Correspondence Between Staff and Applicant

Your Development Application 19-ZN-2013#2, Core Center, is scheduled on the 10/16/2019 Planning Commission hearing agenda.

**RE: 19-ZN-2013 #2 - Core Center  
1<sup>st</sup> Review Comment Responses – Traffic Study Specific**

**JULY 12, 2019 TRAFFIC STUDY-SPECIFIC REVIEW COMMENTS & RESPONSES**

**EXHIBIT**  
**A1**

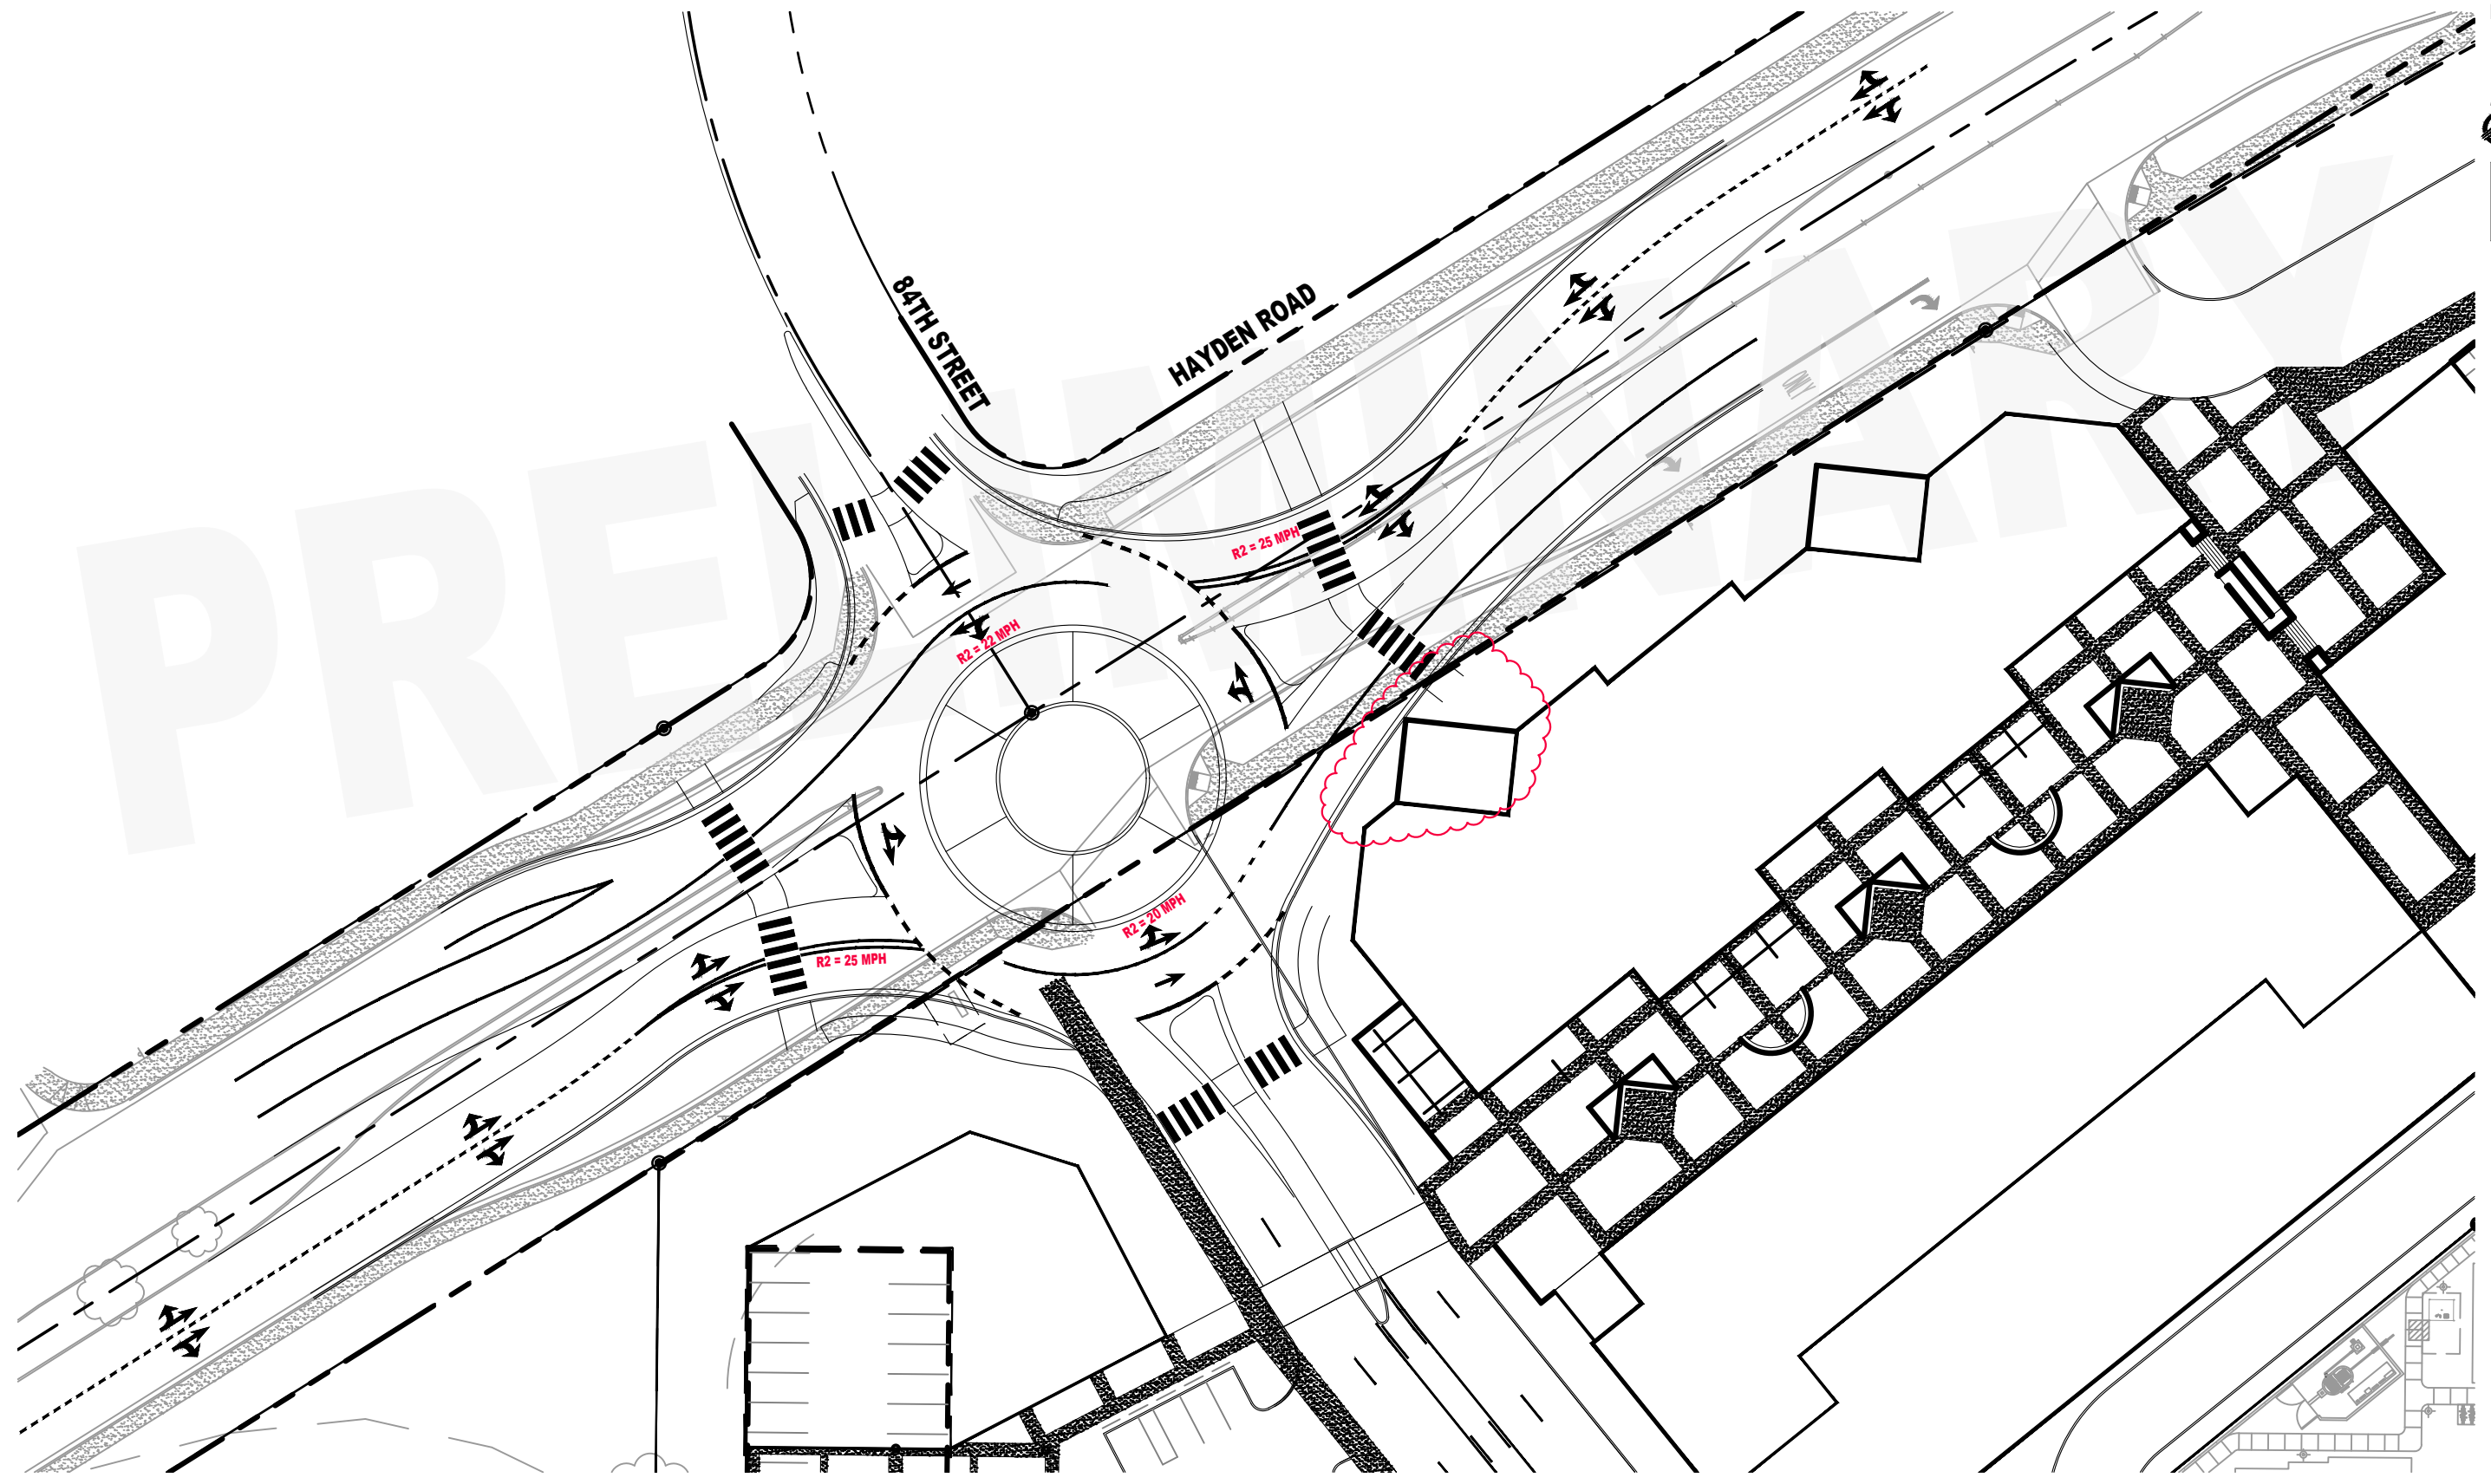
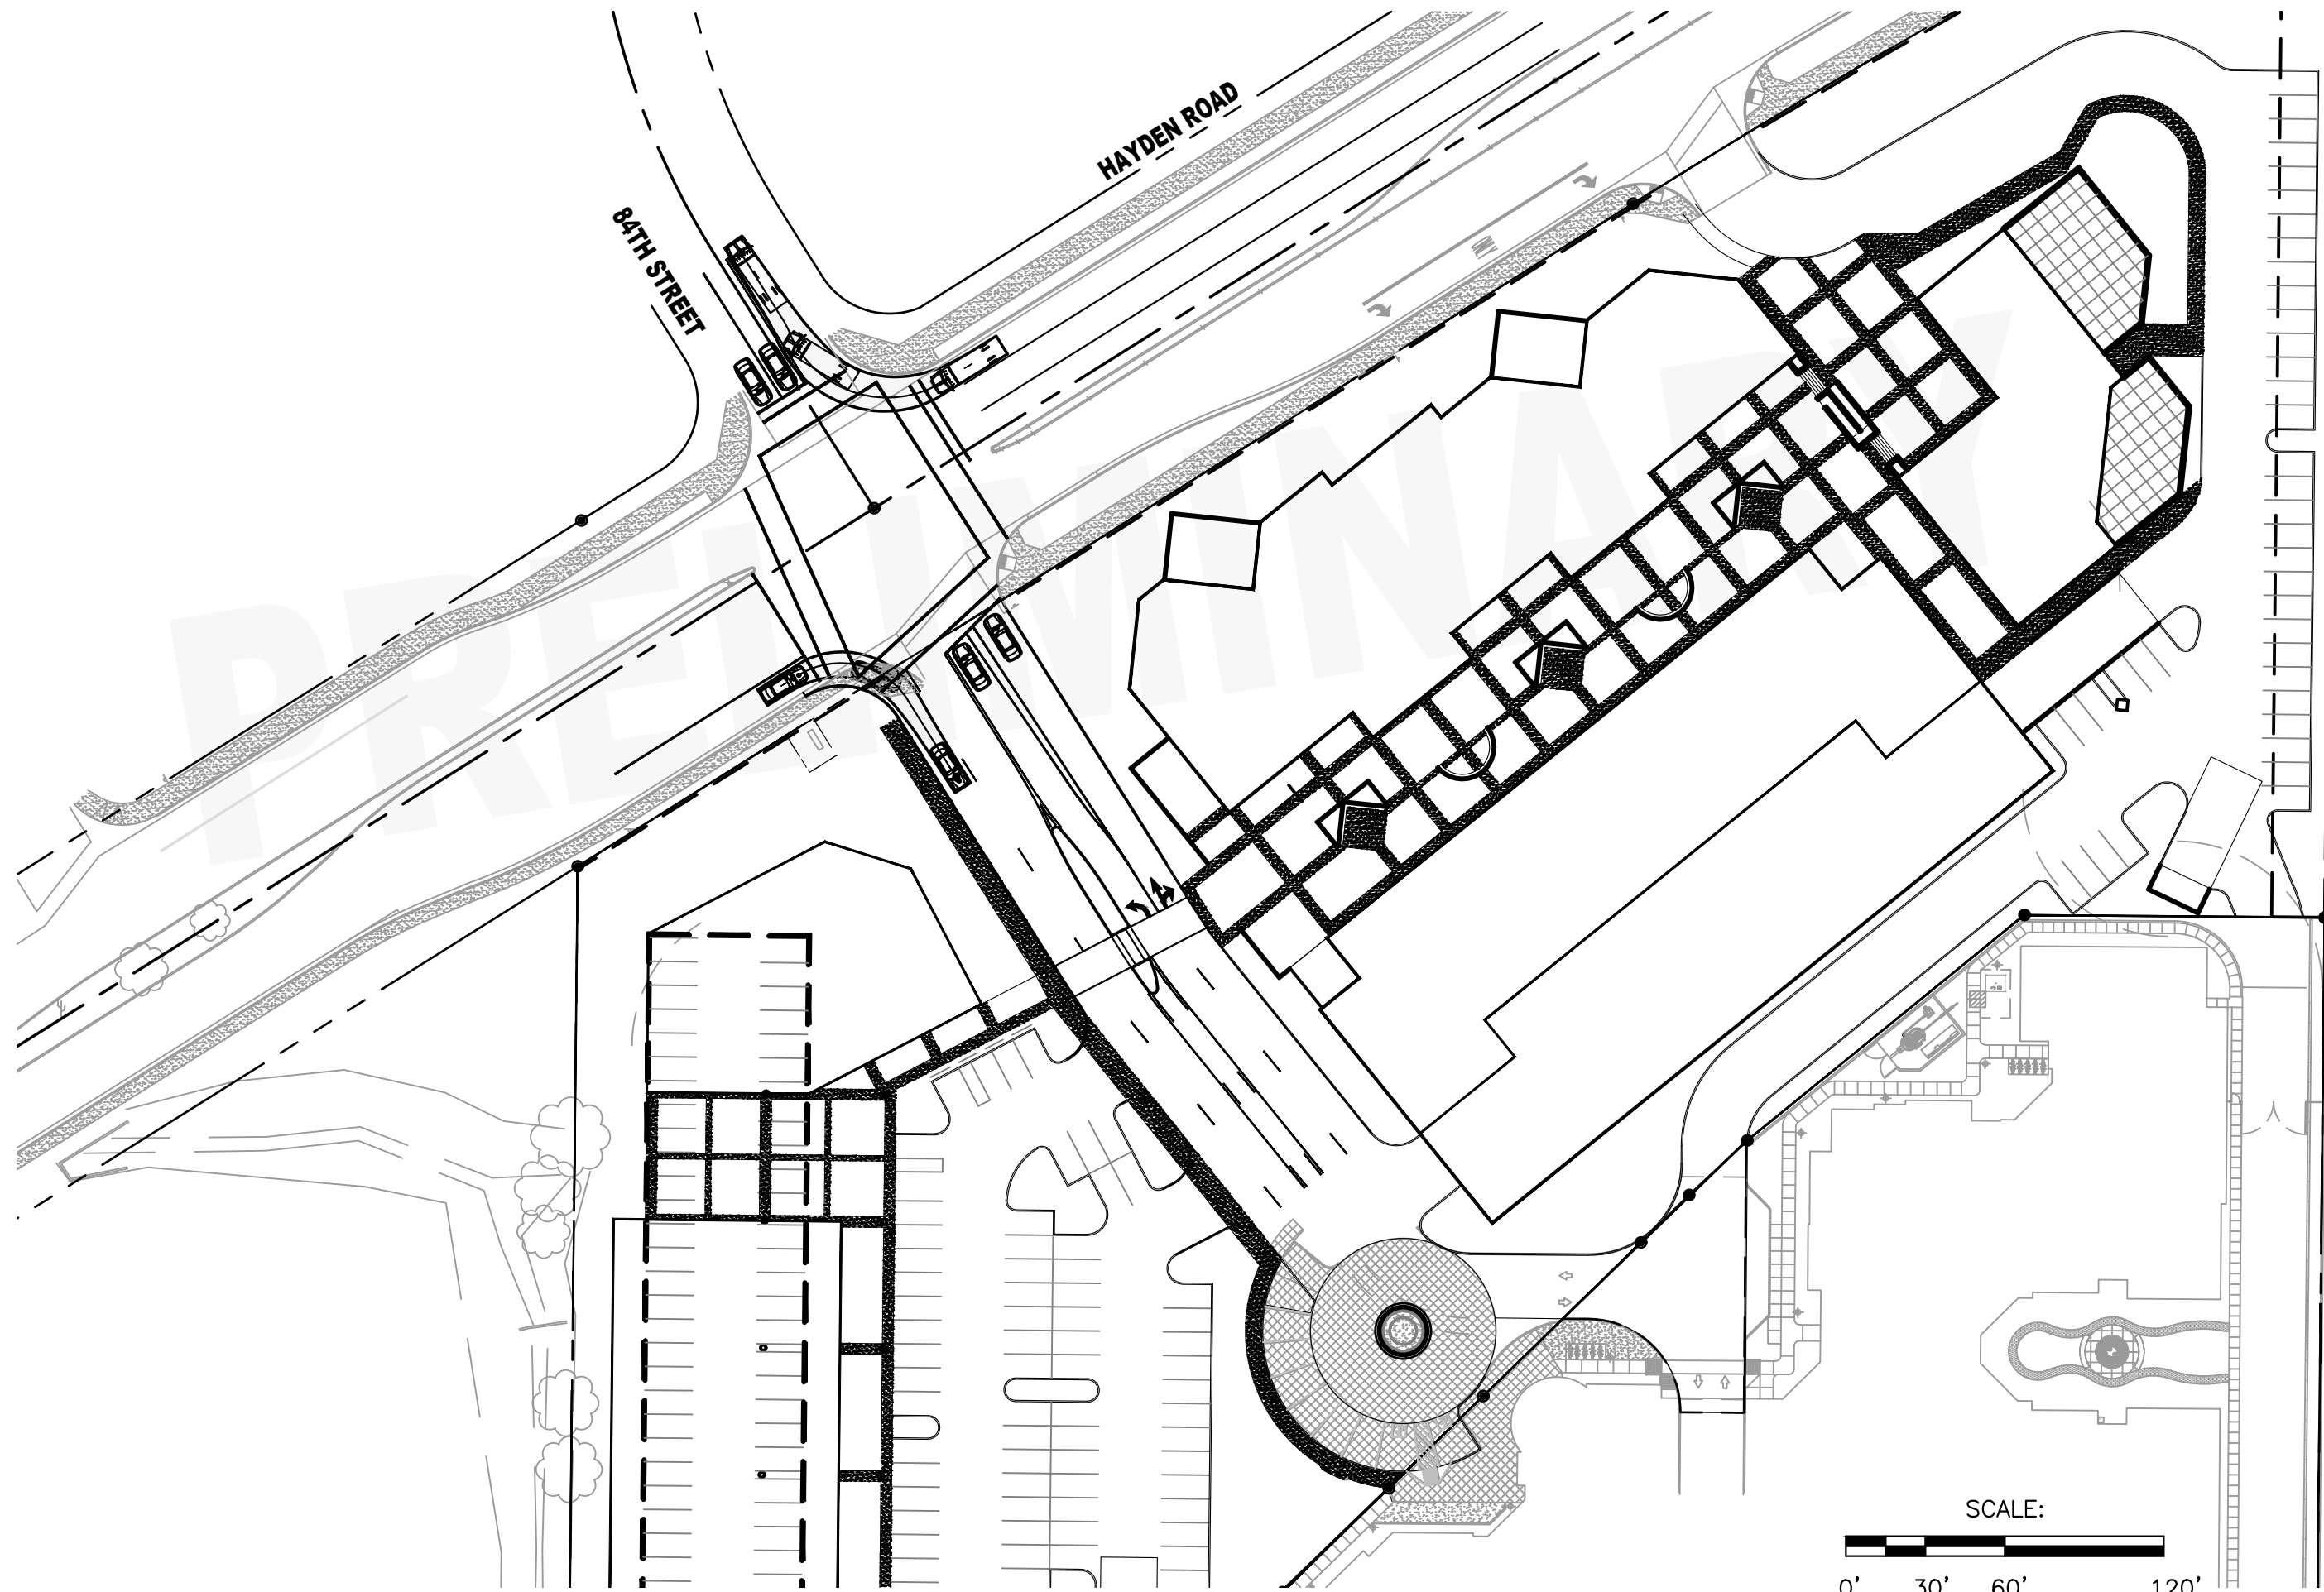
**COS Comment No. 21:** Transportation staff is not fully supportive of the installation of a traffic signal at 84th Street/Hayden Road due to signal spacing. The proposed change from a church to offices and restaurants result in ~ 4x the daily and AM peak hour trips generated and ~10X the PM peak hour trips generated. This has profound impacts on traffic, particularly at the 84th Street/Hayden Road intersection. Signalization was not intended/planned for this location. DSPM 5-3.123 G3 indicates that “At Minor Arterial/Minor Arterial (or smaller designated streets) intersections the designer should evaluate using a roundabout as an alternative to a traffic signal for all new or significantly rebuilt intersections.” The TIMA appears to include no indication that a roundabout option was evaluated. Please address these issues with the next submittal. (DSPM, Sec. 5-3.123)

*We have evaluated the appropriateness of a roundabout from an operational perspective using the roundabout warranting benchmarks specified in Section 5-3.124 of the City's Design Standards and Policies Manual (DSPM) which reads, "**Roundabouts are most appropriate...***

*As to the comment regarding concern over the (quarter-mile) spacing that would result from installing a signal at 84th Street and Hayden Road, based on the understanding that the City is planning to convert the Hayden/Raintree intersection to a roundabout in the not too distant future, there will be an approximately one-mile stretch of Hayden Road with continuous flow endpoint intersections and either one or two signalized intersections in between. It seems therefore that the significance of the quarter-mile spacing of this signal from the 83rd Place and Hayden Road signal should not be as significant as it would be along a longer stretch of arterial with regularly spaced signals.*
